Architectural Review
and Historic Preservation Board
Agenda Report

File: AR 15-28

RE: Lotus Management – New 4-Story Hotel, between Springfield Drive and East 20th Street - Vacant Parcel West of 2080 East 20th Street.

SITE PLAN - PHASE 1

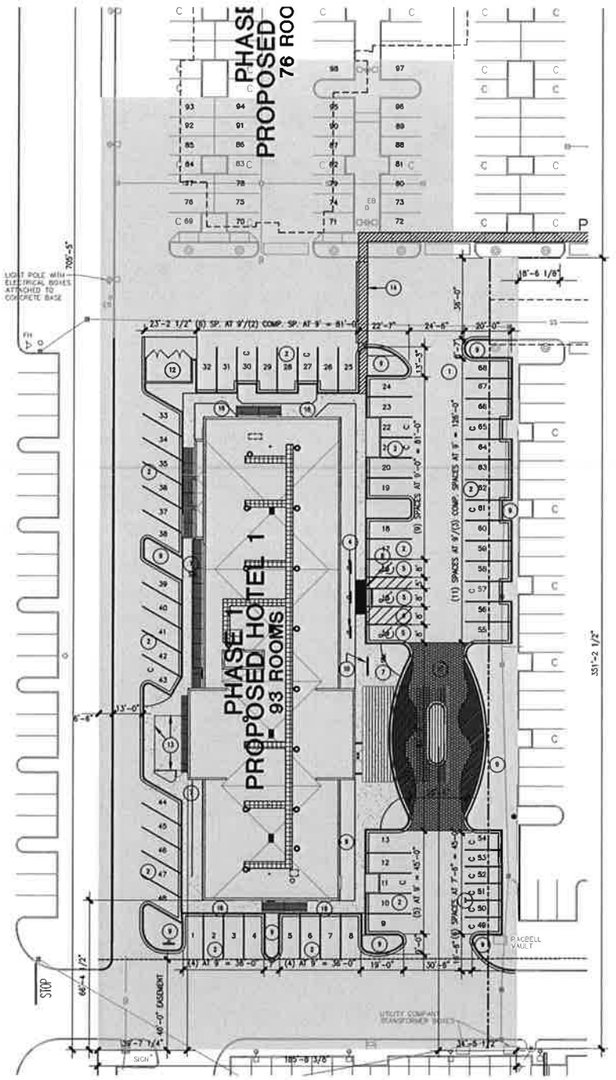
Vehicle access to the site is via a driveway from East 20th Street. With circulation organized in a way to allow customers to access the structure from both the eastern and western frontages. Since parking on the eastern side is designed in a one-way direction, staff is recommending a condition of approval requiring appropriate traffic signage to be installed to minimize vehicle conflicts (see Site Plan, **Attachment C**).

4. Appropriate vehicle signage, including a one-way and a stop sign shall be installed at intersection of the existing driveway and the new one way parking lot on the east side of the proposed structure.

EAST ELEVATION

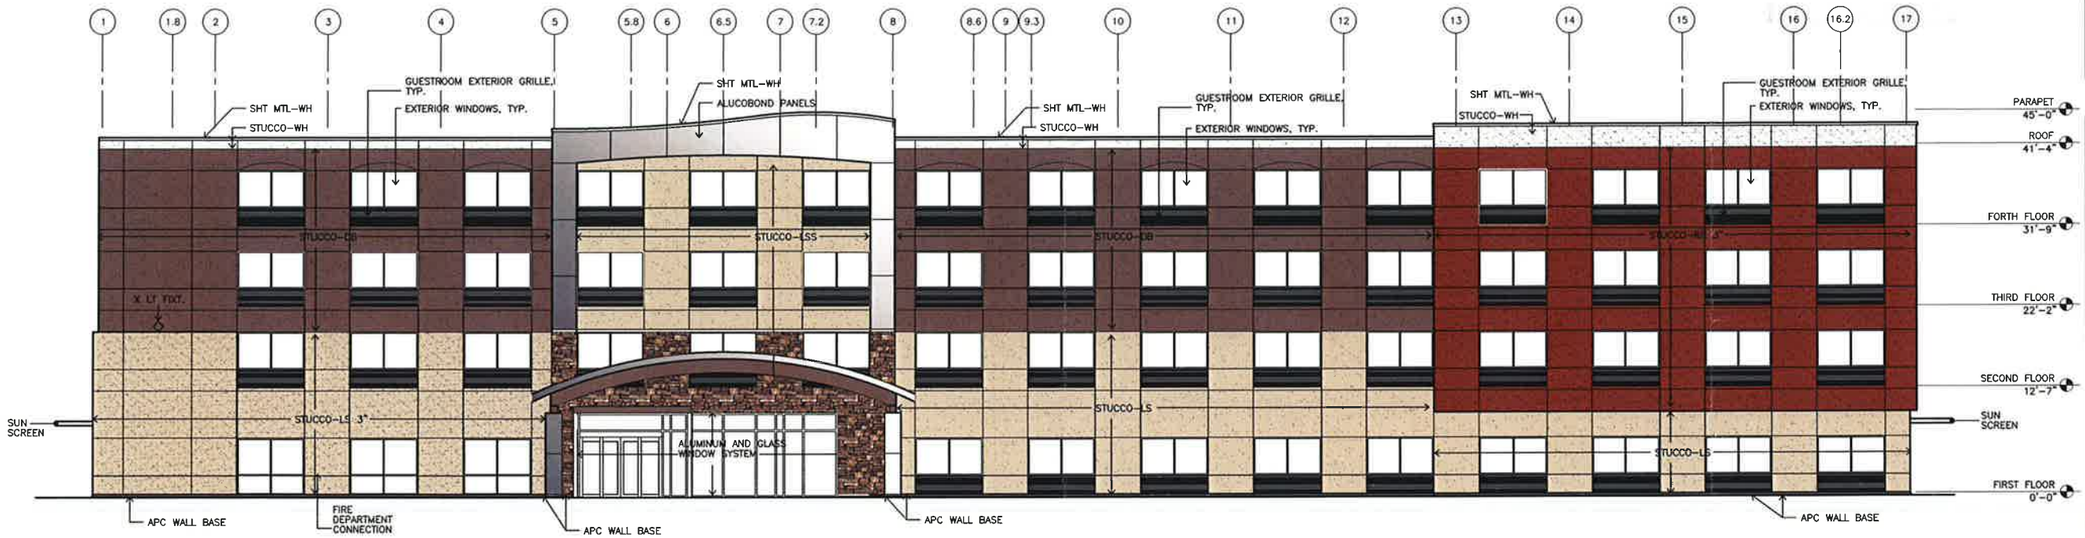
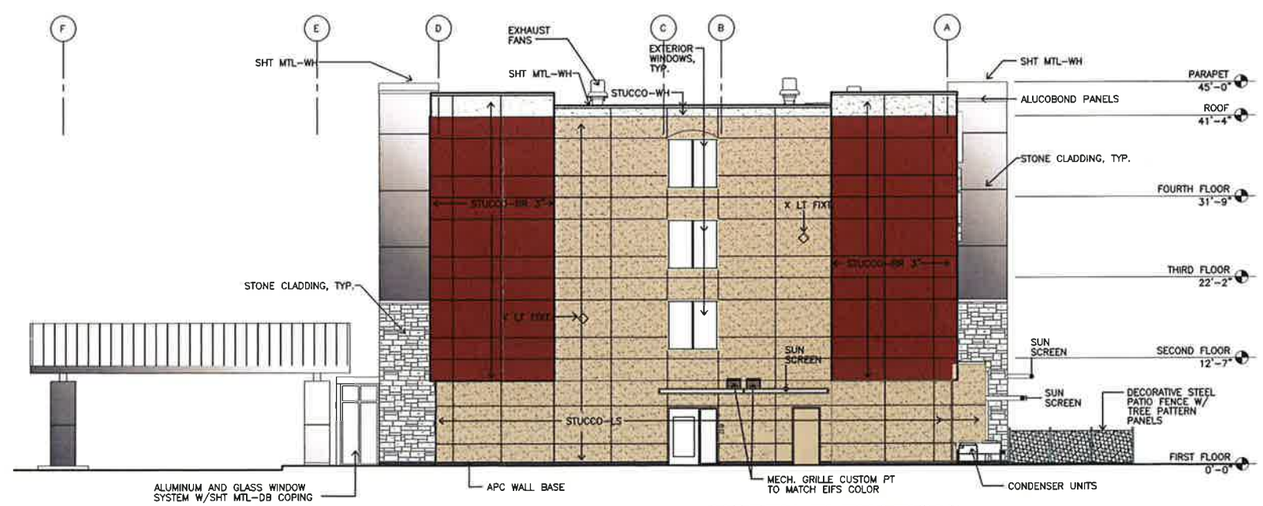
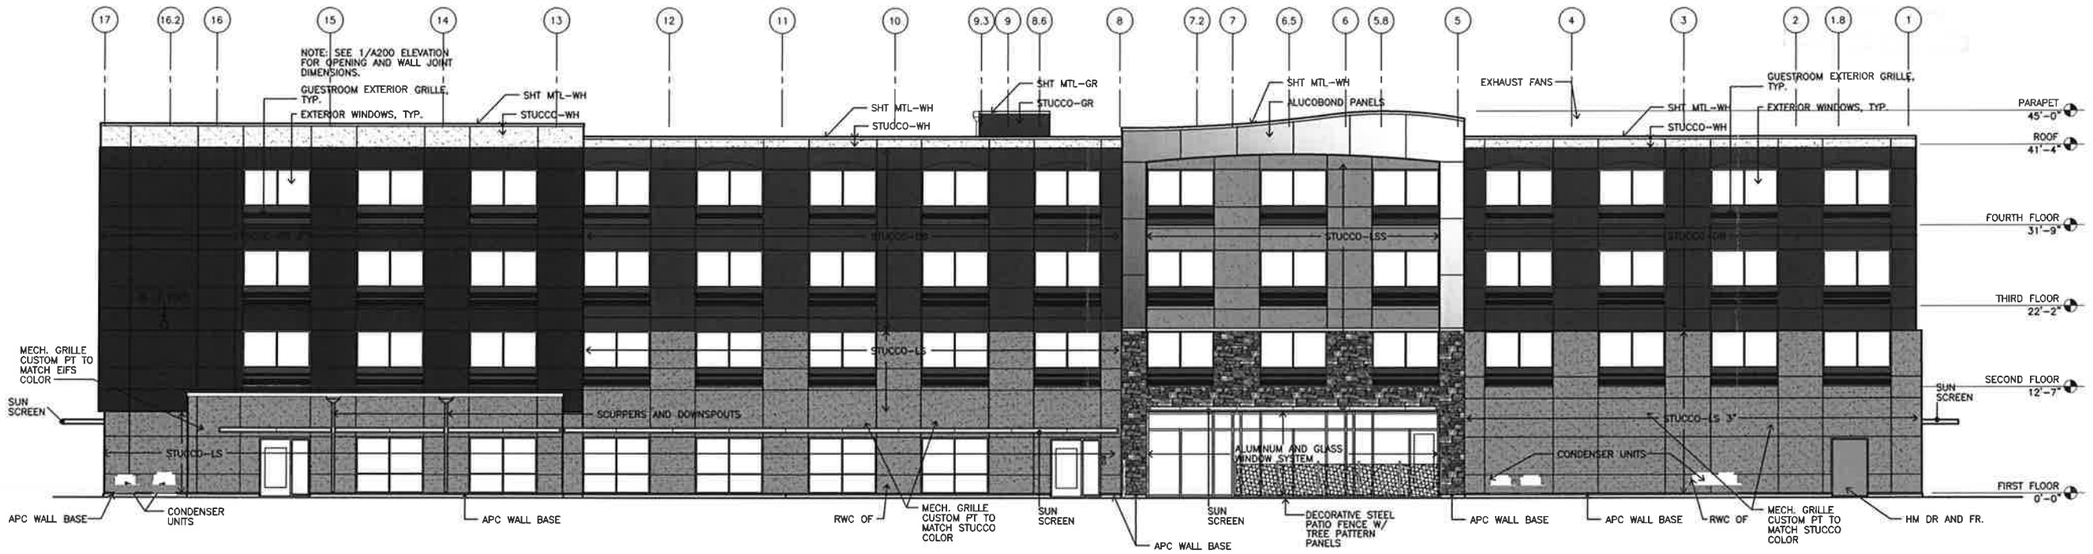
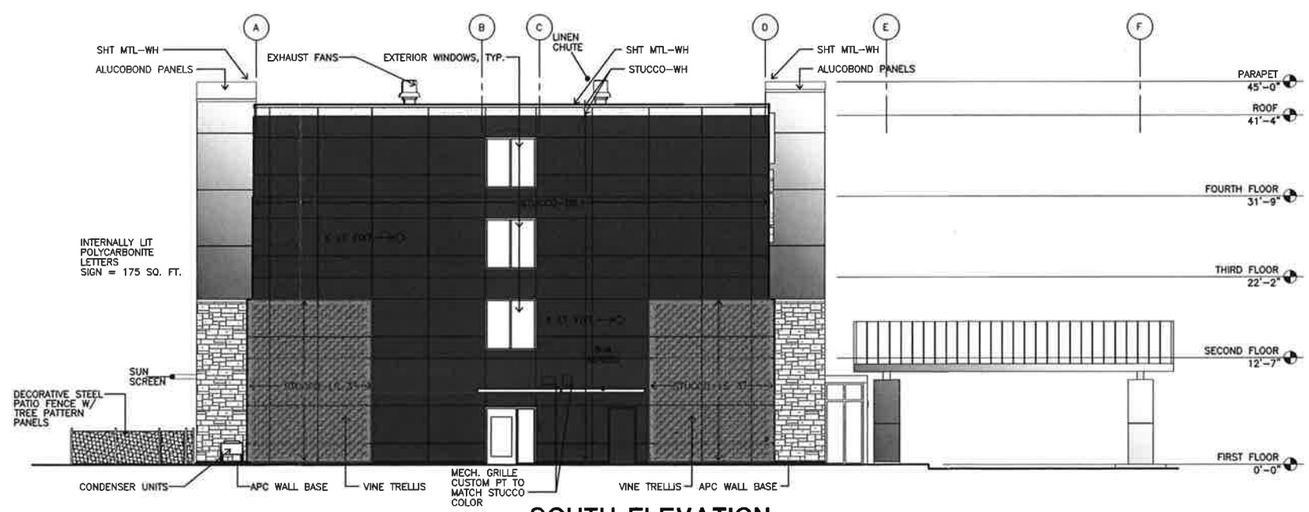
The proposed commercial structure will be 45 feet tall at the parapet and finished with a variety of textures and colors. At each entrance, large aluminum framed glass window systems will be surrounded with stone cladding ("Basalt Stone Veneer"). Each entrance will further be defined with large "alucobond" panels that curve at the top of the structure. Stucco will wrap the remaining portions of the structure and be finished in four paint colors (LS and LSS in "Accessible Beige", DS in "Virtual Taupe", RR in "Rookwood Terra Cotta" and WH "Snowball"). Exterior accent light fixture that will be mounted at different building elevations. Blue wall washer light will be placed at the base of the portico pillars and on the structure, near each entrance (see Color Elevation, **Attachment D**). A color material board will be presented at the public hearing.

Vehicle entrance porte cochere is well defined with decorative pavers to welcome guest. Up wall washing lighting is proposed in a blue hue, further defining the structural entrance. Wall light fixtures provides additional interest as it shines out in four directions from the fixture. Chico Municipal Code prohibits exterior up lighting of structures, therefore staff is requesting the Board to discuss with the applicant appropriate light details with the applicant. Parking lot lighting detail is not known, therefore staff has placed a condition of approval requiring lighting to not exceed 18 feet in height.

The roof design is flat with the exception of the alucobond panels at the top that have a slight wave feature to them. A parapet wraps around the entire structure to hide roof mounted equipment (DG 1.3.78). Sun screens are placed over pedestrian entrances to define access points (DG 1.3.75).

<u>Up Lighting</u>
Discuss with the applicant the alternatives to up-lighting and fixtures that shine in 4 directions.

6. Up lighting of the structure is prohibited.

PRELIMINARY LANDSCAPE MASTER PLAN

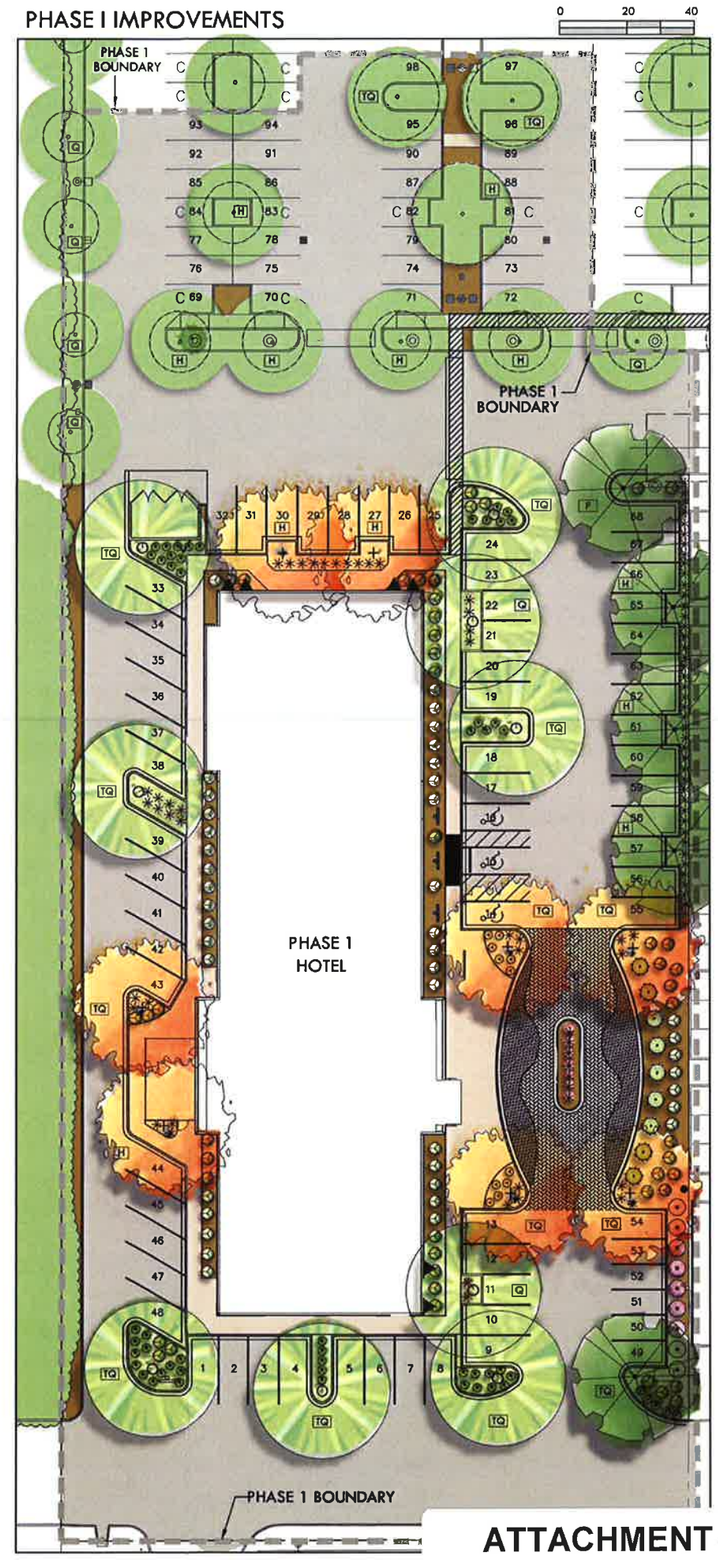
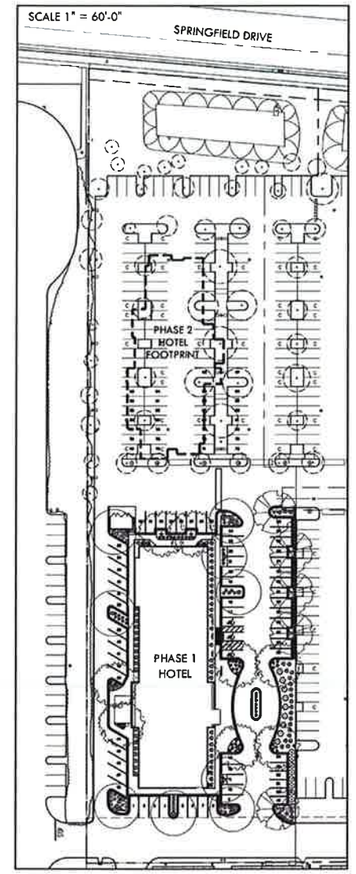
Landscaping is planned throughout the site, with a combination of Sycamore, Zelkova, and Chinese Pistache trees to meet the 50% parking lot shade requirement. Shrubs and

flowering ground cover are also proposed to soften the structure's appearance to the street, and provide additional accent. Large trellis structures, with vines will be placed on the south elevation. A patio area on the eastern side of the structure will have a decorative metal fence with tree pattern panels (see Landscape Plan, **Attachment E**).

Landscaping is provided throughout, which will provide additional color and interest to the site. Flowering ground cover, and trees that turn bright, bold colors during the fall provide increased awareness and a seasonal color pallet to the project. Two large trellis elements will be installed along the southern elevation, softening the structure to passing motorist.
